ISSUE: Certificate of Appropriateness for alterations (signage)

APPLICANT: King Arthur Baking Co, represented by Patience Shaffer

LOCATION: Old and Historic Alexandria District
615 King Street

Night View

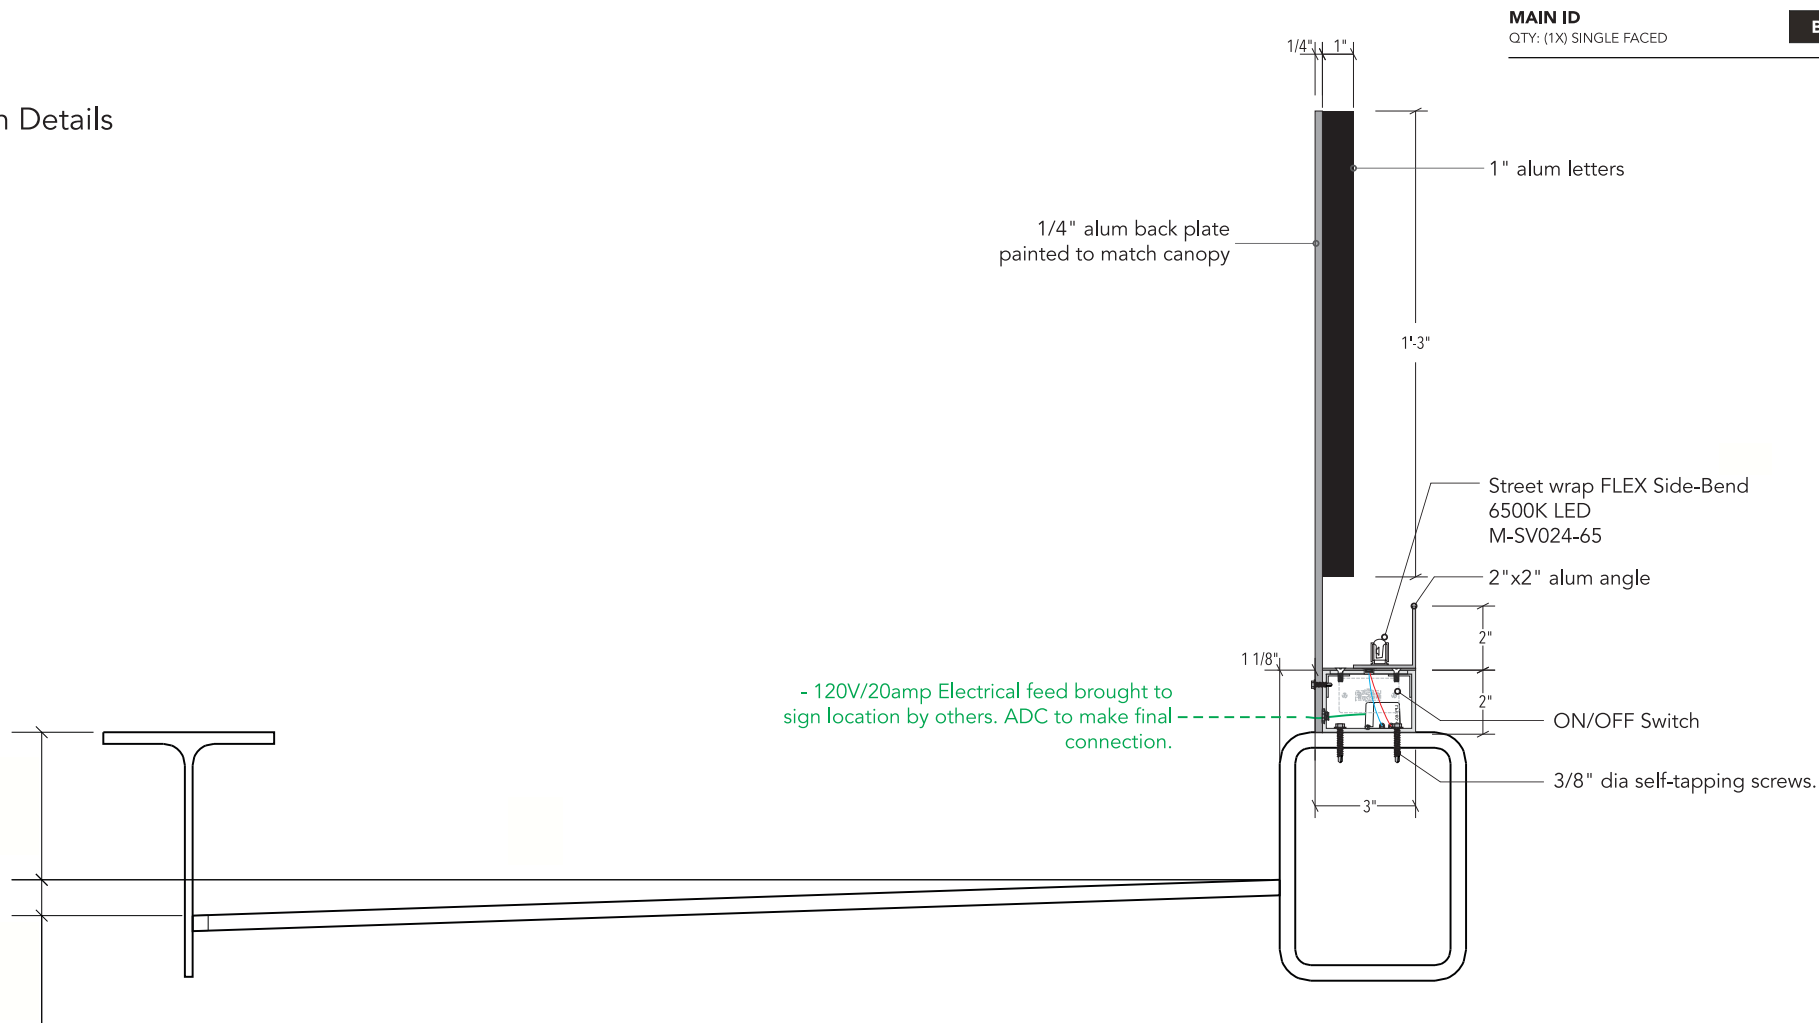
The applicant proposed an external uplight of 6500K. Staff recommends approval with the condition that the illumination shall be no greater than 150 lumens and the color of the light should be warmer rather than whiter/cooler and no greater than 3000K.

Staff recommends approval of the Certificate of Appropriateness for signage with the condition that the illumination shall be no greater than 150 lumens and the color of the light should be warmer rather than whiter/cooler and no greater than 3000K.
